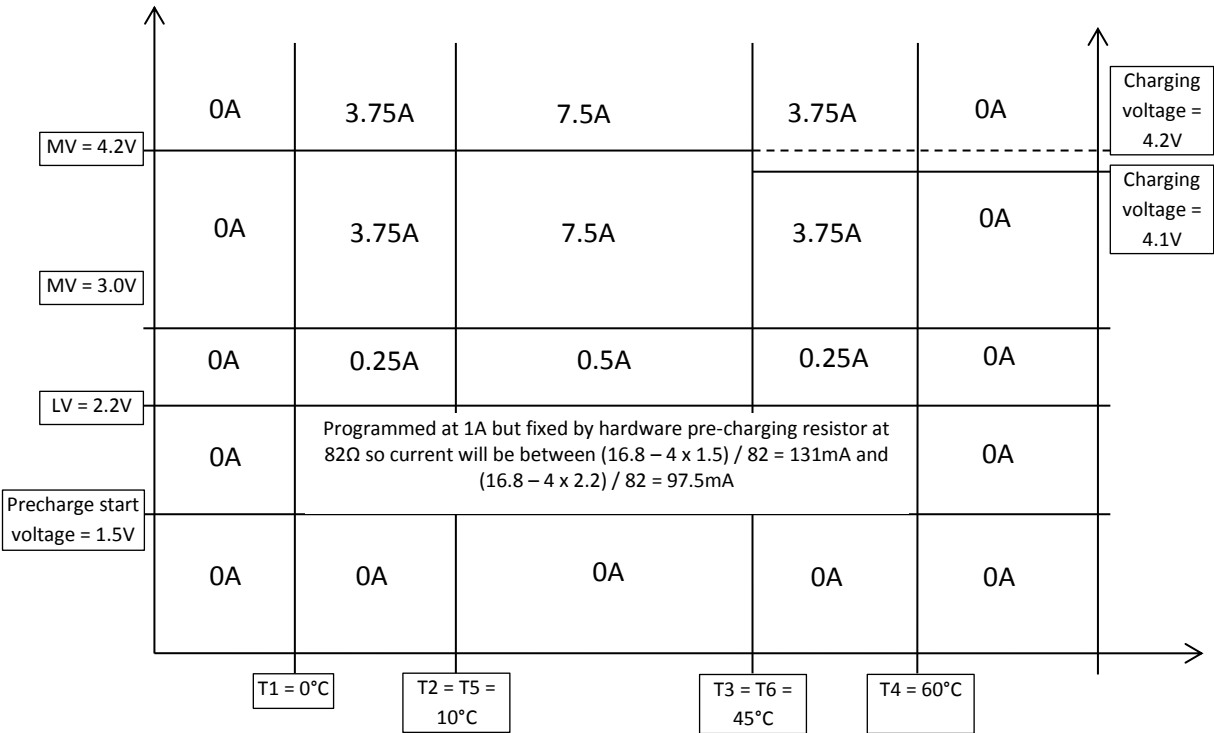
Today we have programmed Charging Current versus Temperature and Charging Voltage as following table:

Is there really a difference about the two settings because in both case, we have the same charging current from MV (3.0V) to 4.2V?

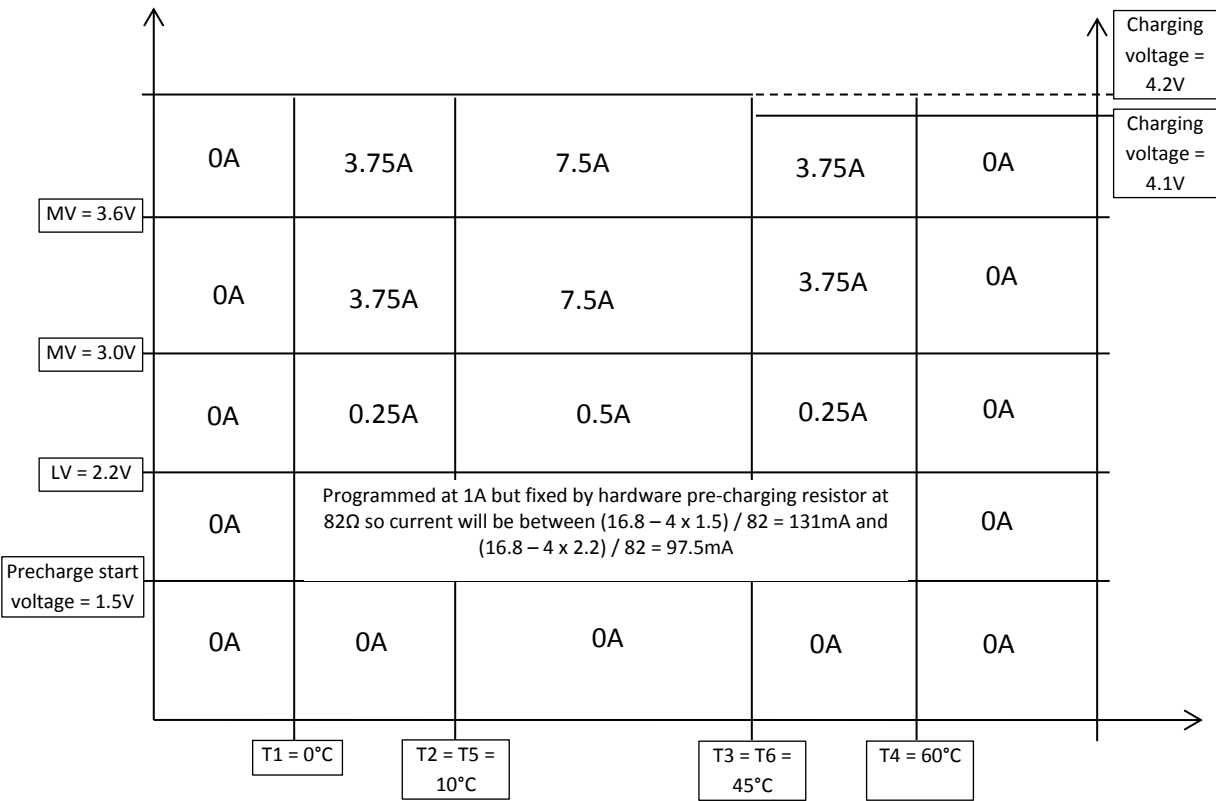
We could have programed like that :
